City of Oakley

ADDENDUM NO. 1 to contract documents for
LAUREL ROAD WIDENING PROJECT, CIP # 196

BID OPENING DATE: November 20th, 2018 2:00 PM

Date: 10/19/2017	Revisions
Scale: AS NOTED	20181019 ADDENDUM No. 1
Design: CC	
Drawn: AH	
Approved: MC	
Job No: 2017095-10	
Drawing Number:	
GD-4	
27 OF 58

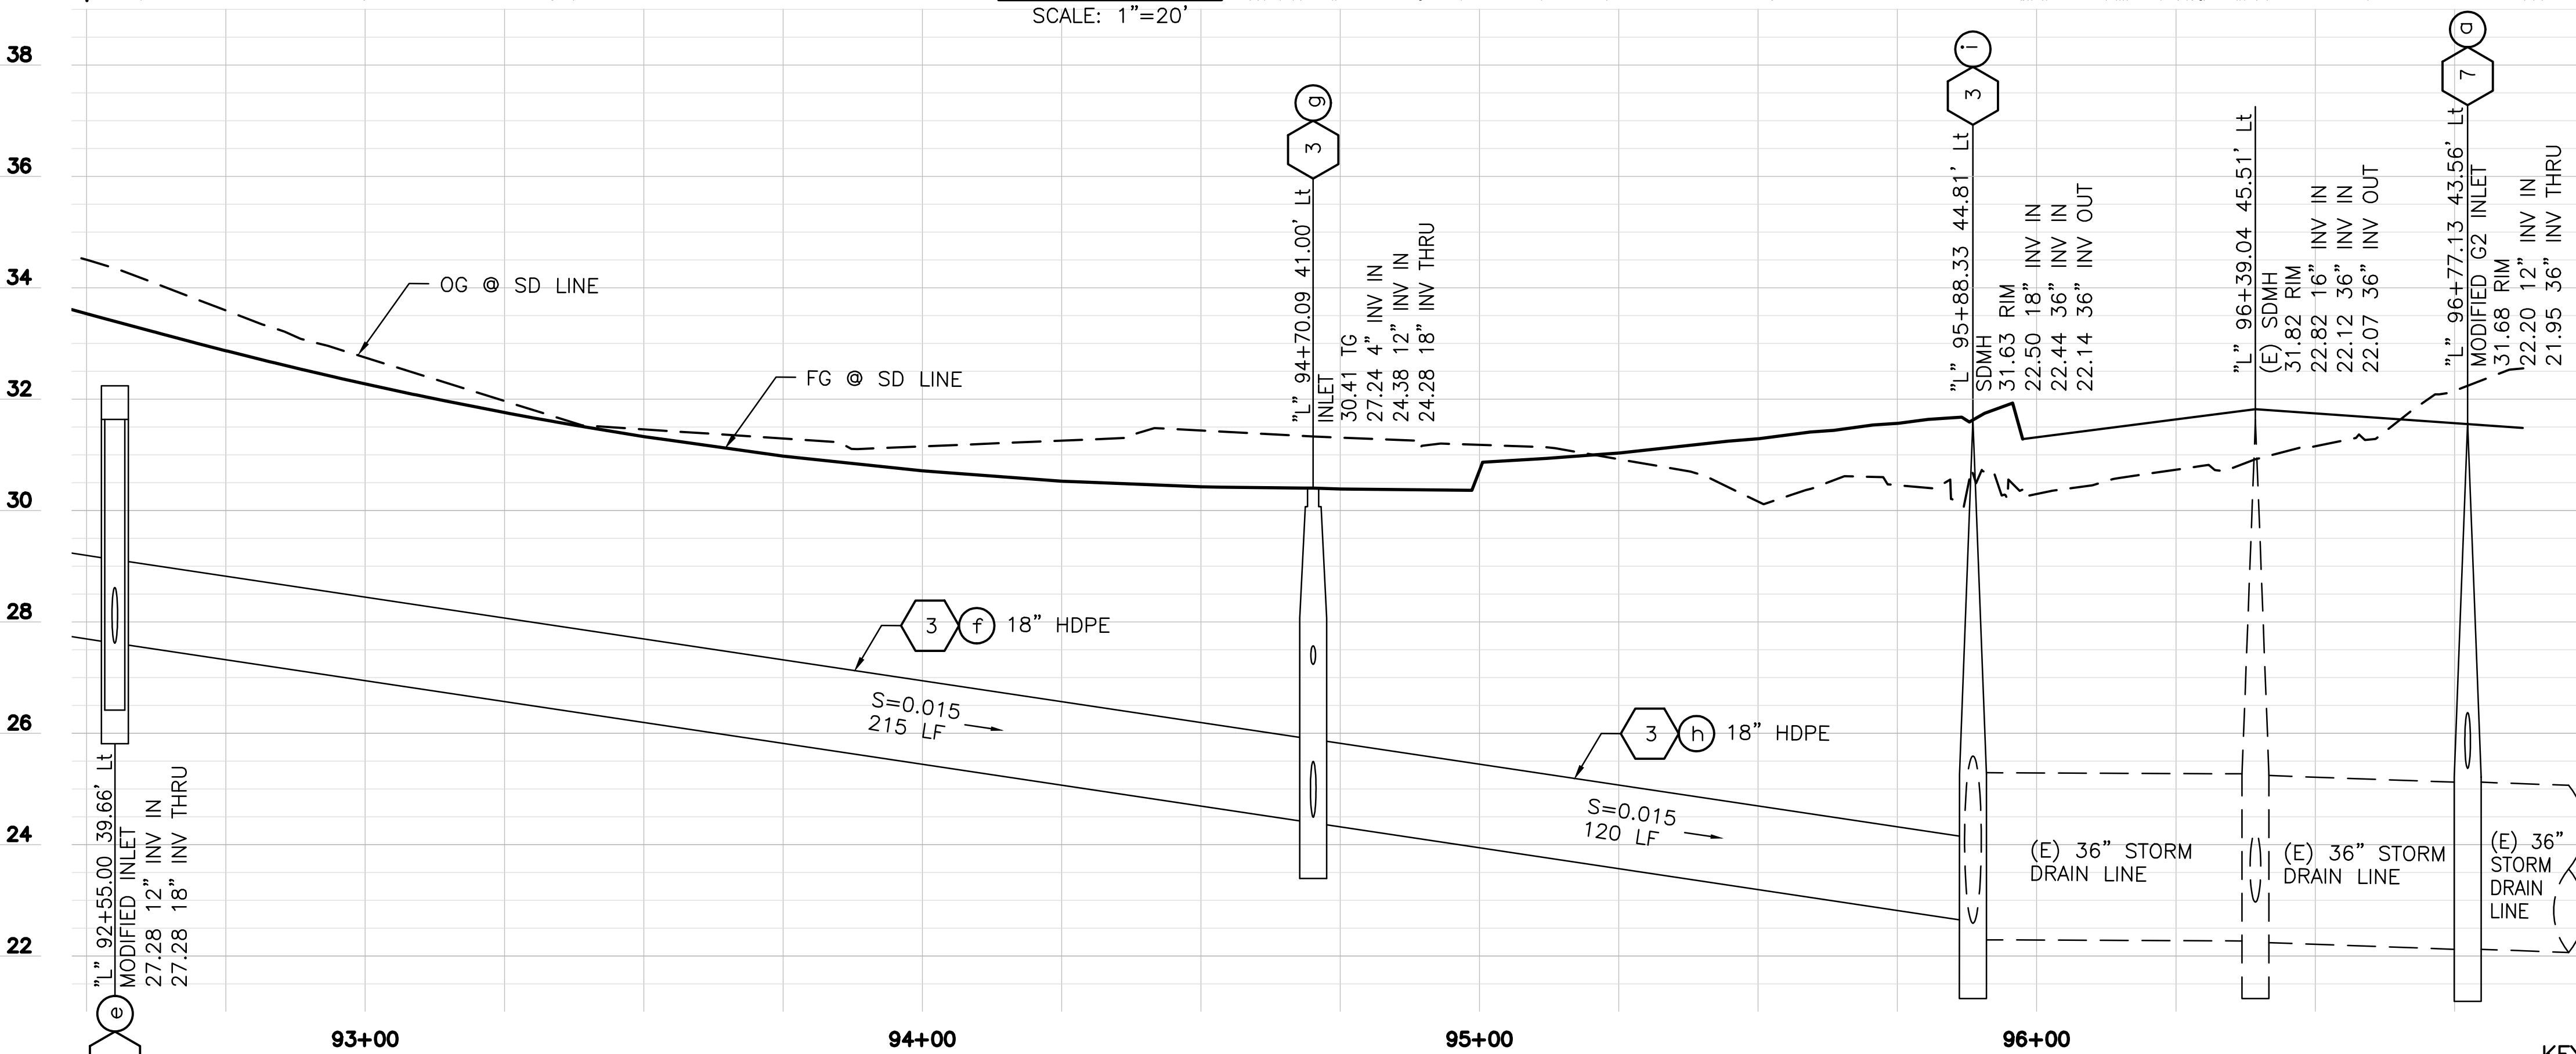
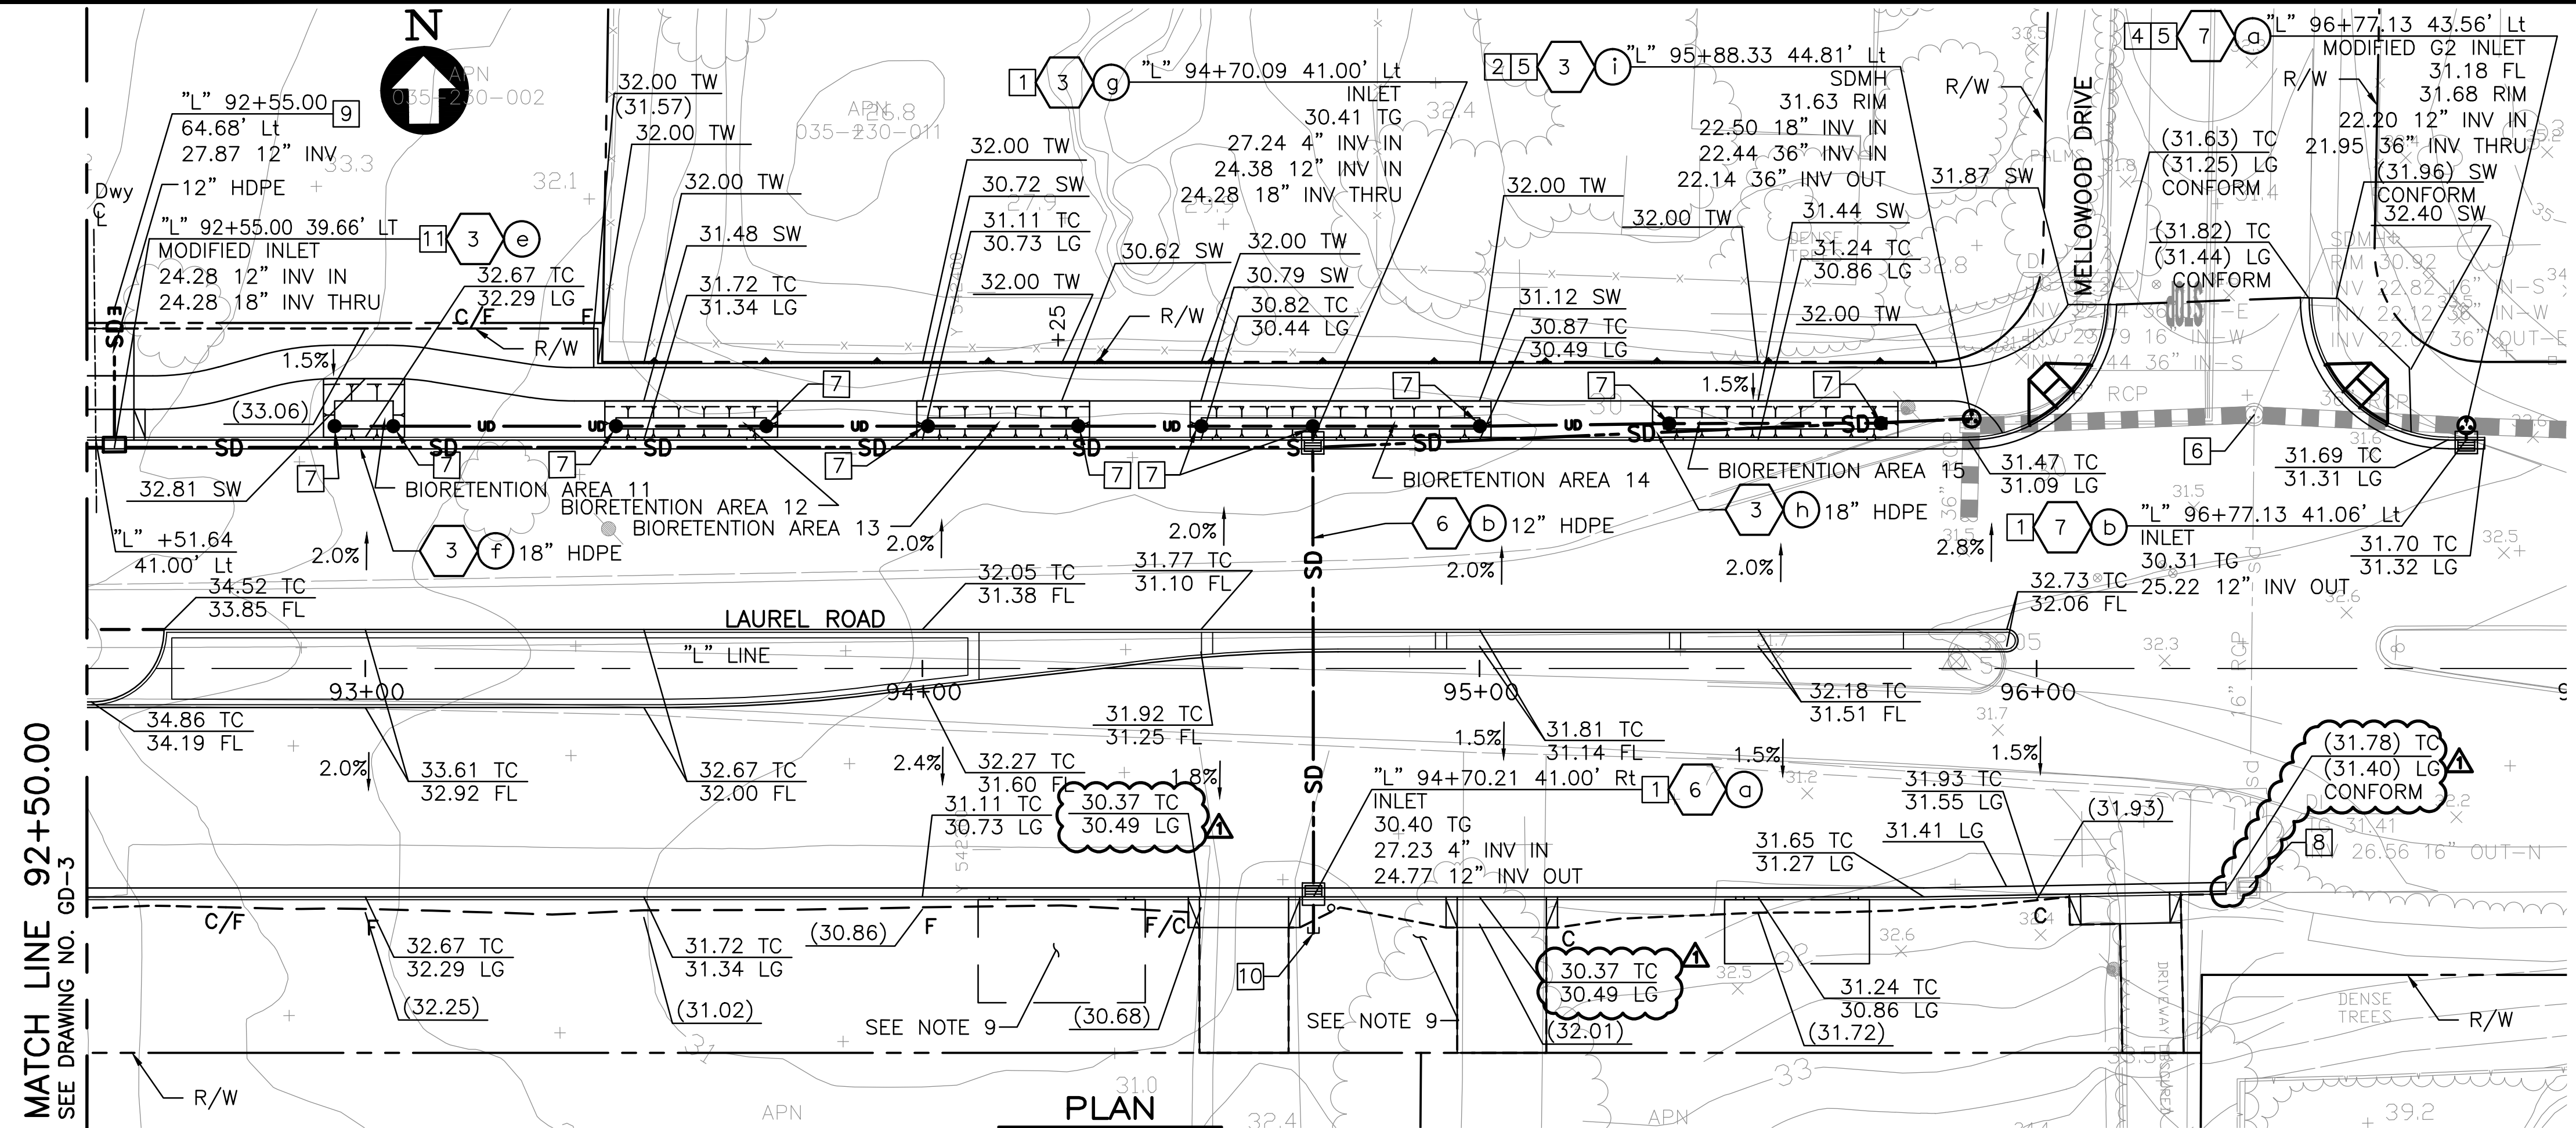
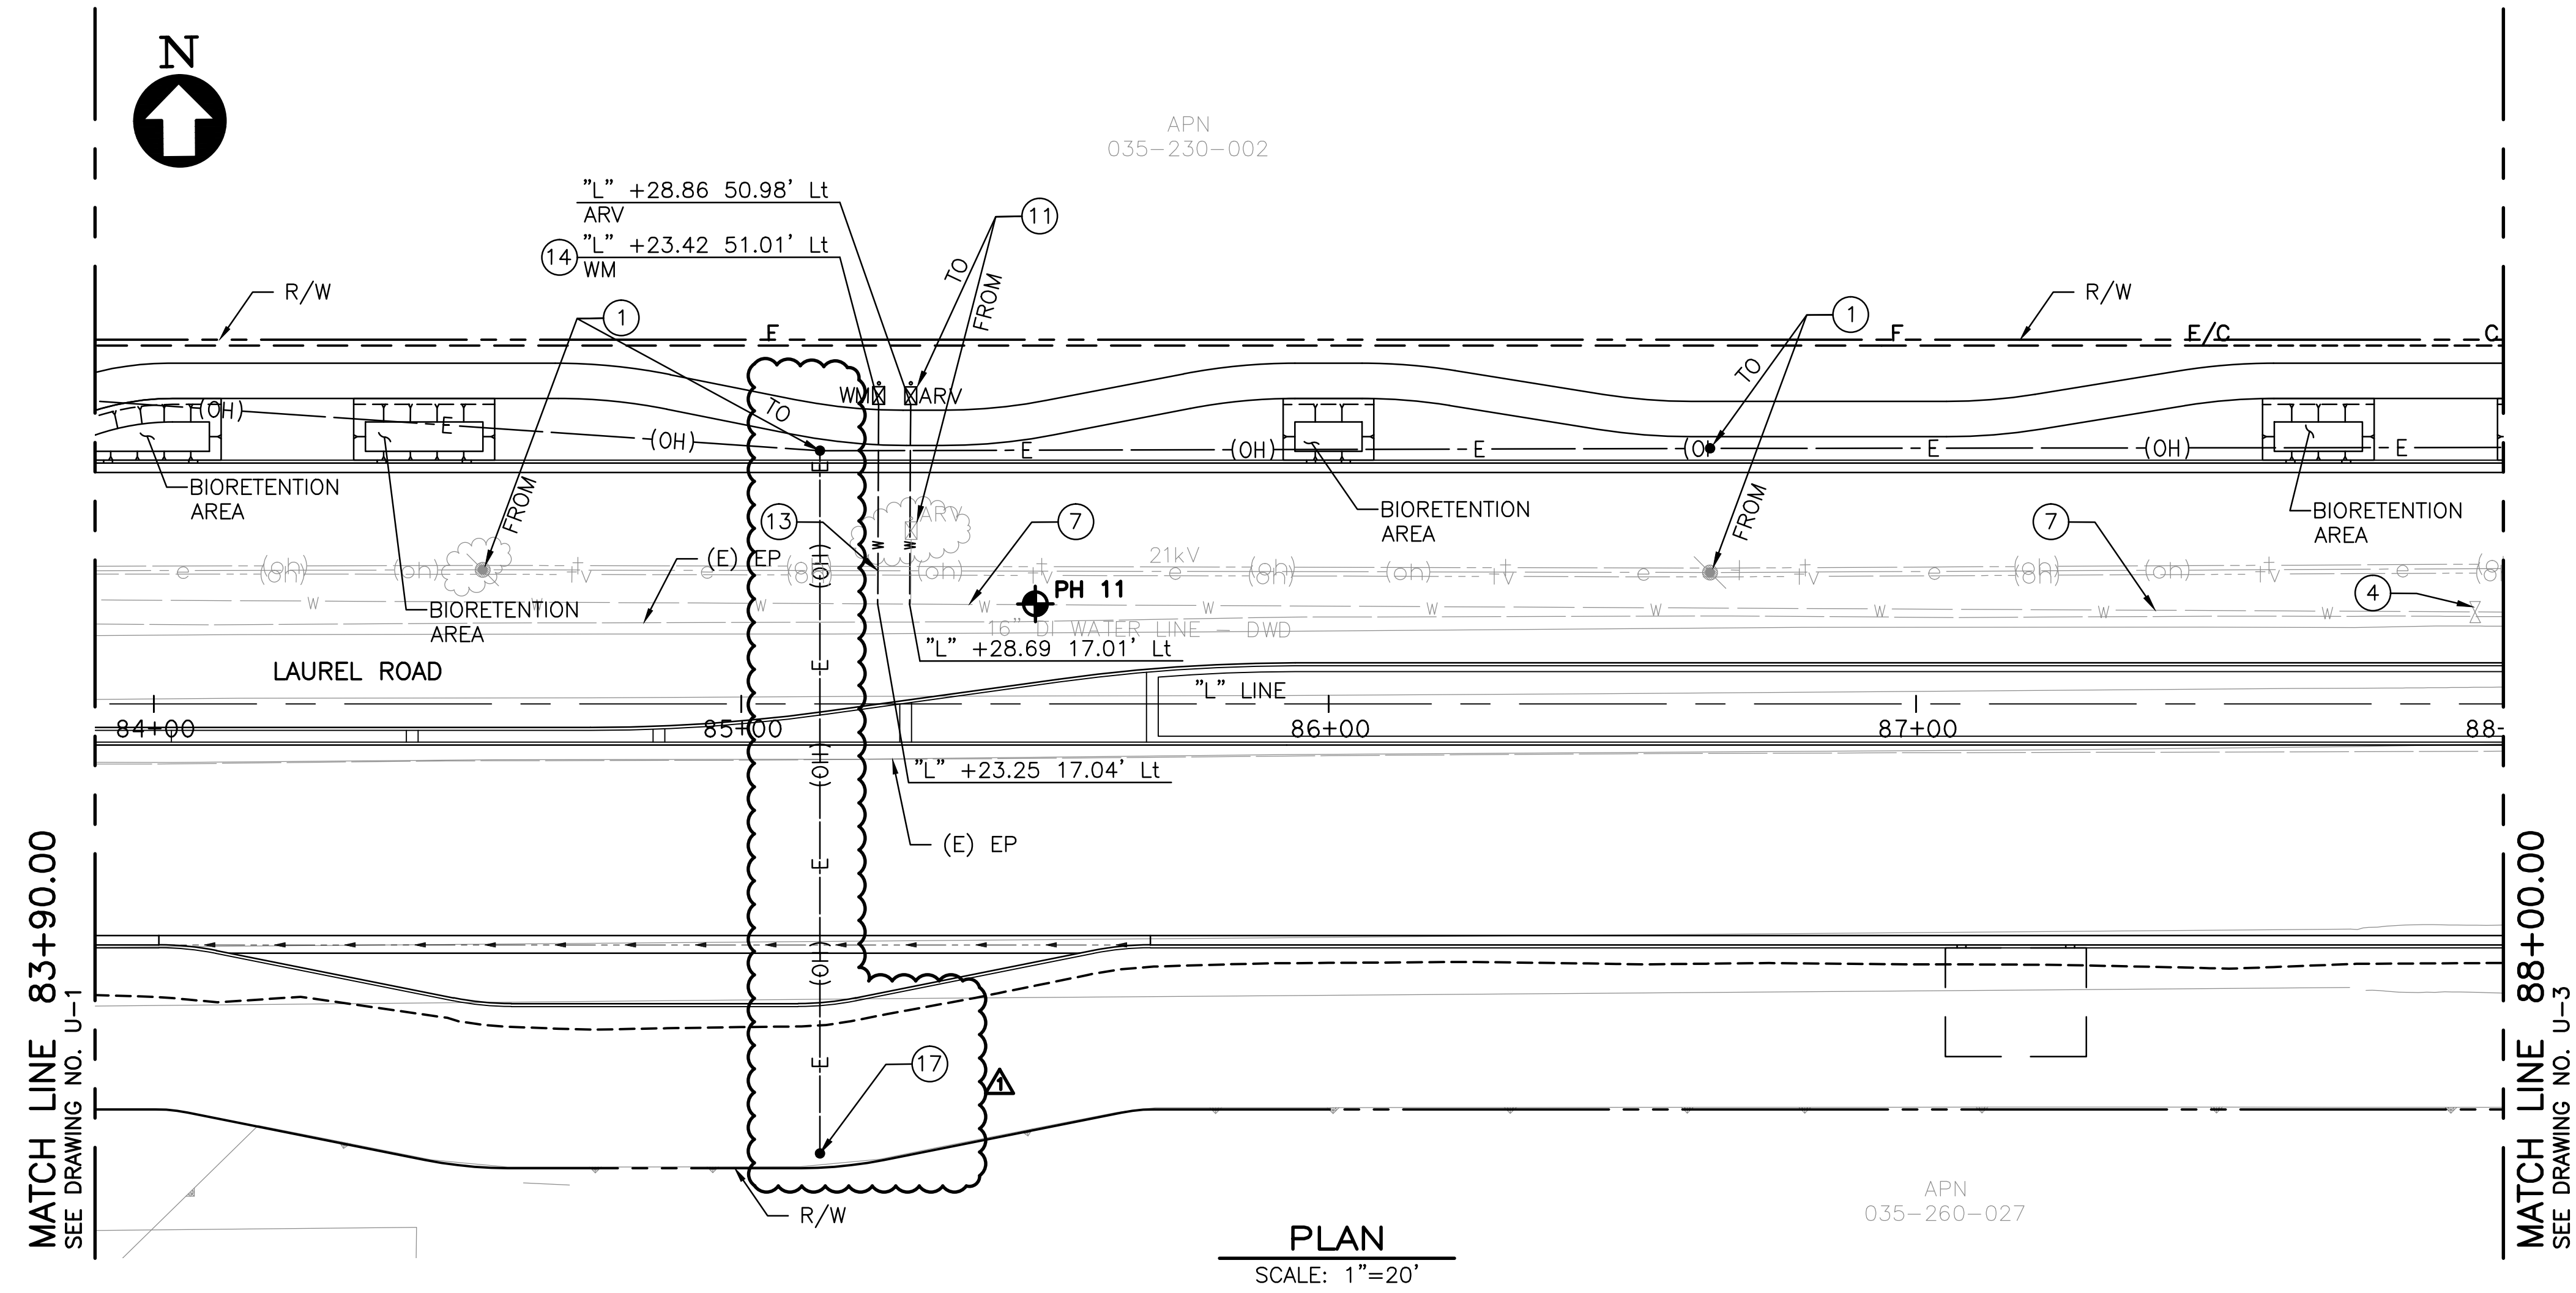
- Updated Sheets DM-4, S-1 to S-4, CD-5, GD-4 and U-2
